Channel 9 Site Concept Plan Modification 4

Modifications to Concept Approval for Residential
Development at the former Channel 9 Site, Willoughby
(MP10_0198 MOD 4)

August 2020

Subtitle: Major Project Modification Assessment (MP10_0195) MOD 4

Figure 12 | Building K envelope height as initially proposed in the EA (above) and refined in the Proponent's SRtS (below) (Base image source: EA and SRtS)

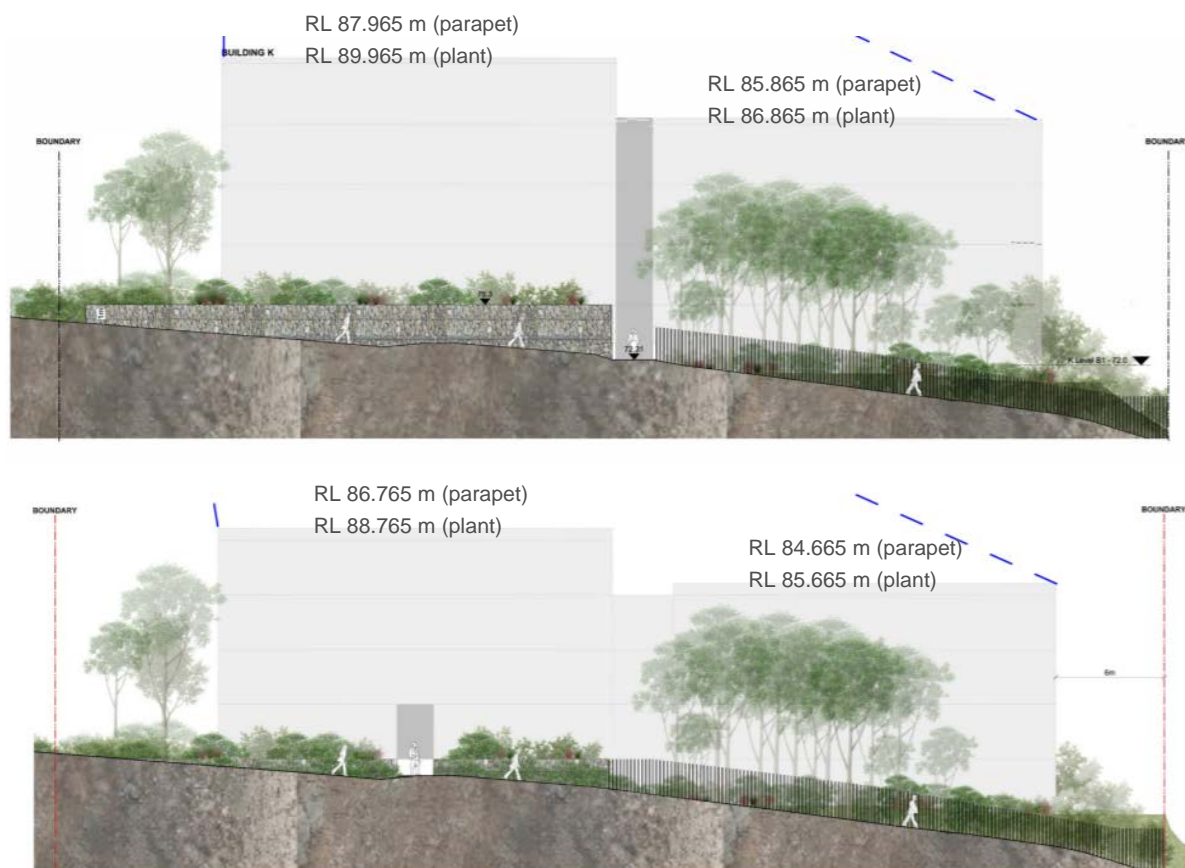
- reduction in building envelope height by 1.2 metres (**Figure 12**)
- increased southern setback to a consistent 6 metre setback
- adaptive reuse of elements of the transmission tower subject to confirmation of suitability.

Council and public submissions raised concern with the height of the building as originally proposed, noting that the northern part of proposed Building K adopted the same height of adjacent Building H despite being located downhill from that building, and therefore not stepping down with the topography.

In response, the Proponent amended the building envelope heights in the SRtS, so that the northern parapet of Building K would be 1.2 metres below the approved parapet of Building H, stepping down another 2.1 metres in the southern part of the building (**Figure 13**).

Overall, the Department considers the proposed 4 – 5 storey envelope height represents a significant improvement from the existing visually imposing tower on the site (equivalent to approximately 77 storeys) which dominates the streetscape and the skyline.

Figure 15 | Extract from proposed building envelope plan showing boundary setbacks (Base image source: SRTS plans)

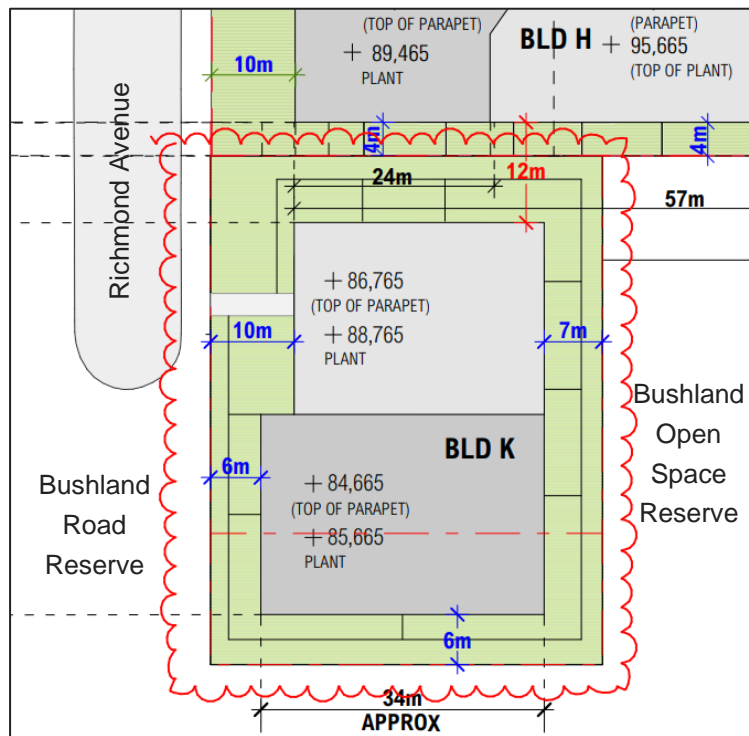
Council raised concern that the envelope would extend as close as 3 m to the southern boundary and adjacent urban bushland. Council recommended a uniform 6 m setback should be provided to enable more substantial planting in the setback area to better integrate the development and be more sympathetic to the surrounding bushland.

In response to Council's concerns, the Proponent amended the scheme in the SRtS to provide a consistent 6 m setback to the southern boundary. The proposed building envelope setbacks are demonstrated in **Figure 15**.

The Department supports the 6 m southern setback to enable preservation of the natural values of the adjoining bushland and to provide opportunity for setback plantings to assist with screening the building and integrating it visually with the adjacent reserve areas.

Figure 16 | Site survey Plan overlaid with building envelope plan indicating possible line of embankment (Base image source: site survey and SRTS plans)

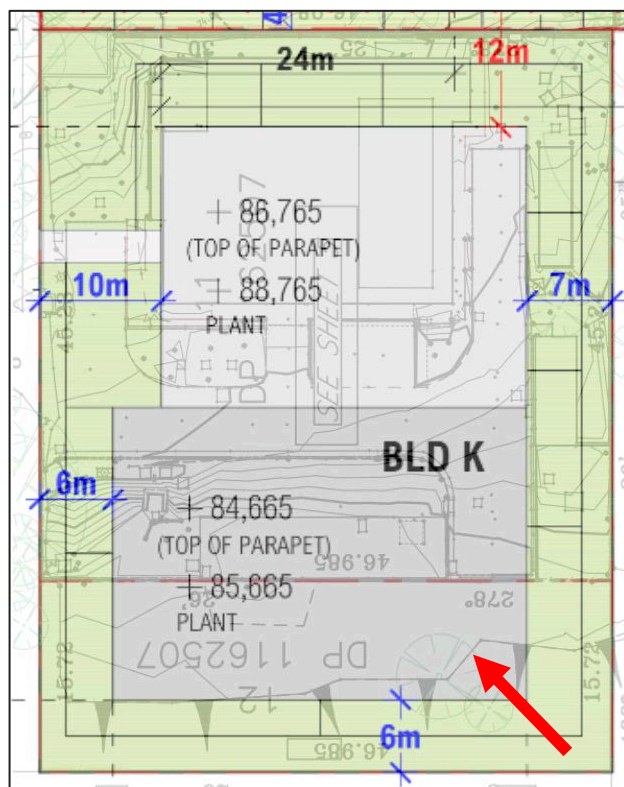
However, the Department notes that there is a steep embankment in the southern part of the site. While some plans submitted with the modification indicate the proposed setback would ensure the embankment would be located to the south of the proposed envelope, an overlay of the survey with the proposed envelope plans indicates the building may extend over the embankment (**Figure 16**).

The Department considers that the building should respond to the topography of the site and therefore recommends a FEAR that should the future building extend beyond the top of the embankment, the building shall be designed to respond to the topography in this part of the site. Subject to this condition, the Department is satisfied the 6 m southern setback will ensure the future building on the site would respond appropriately to its bushland setting.
